PRODUCT/PROCESS CHANGE NOTICE (PCN)

PCN #: **SR-0505-02** DATE: **8/3/2005**

Product Affected: FPBGA 165 (BQ165) Package

ATTACHMENT - PCN #: SR-0505-02

Example of FPBGA 165 Package Top Mark

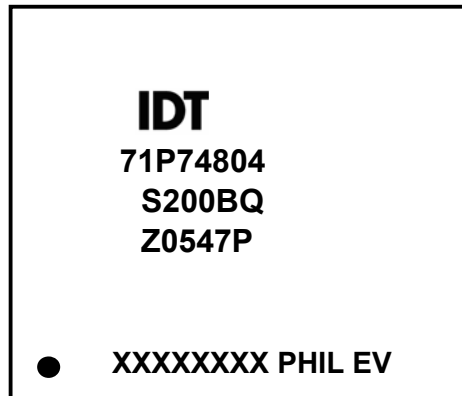
Encrypted assembly date code suffix on the assembly lot number

XXXXXXXX = Assembly Lot Number
PHIL = Country of Origin
EV = Assembly Date Code

EV
└─┬─> ww 45 - 46
└─┬─> 2005
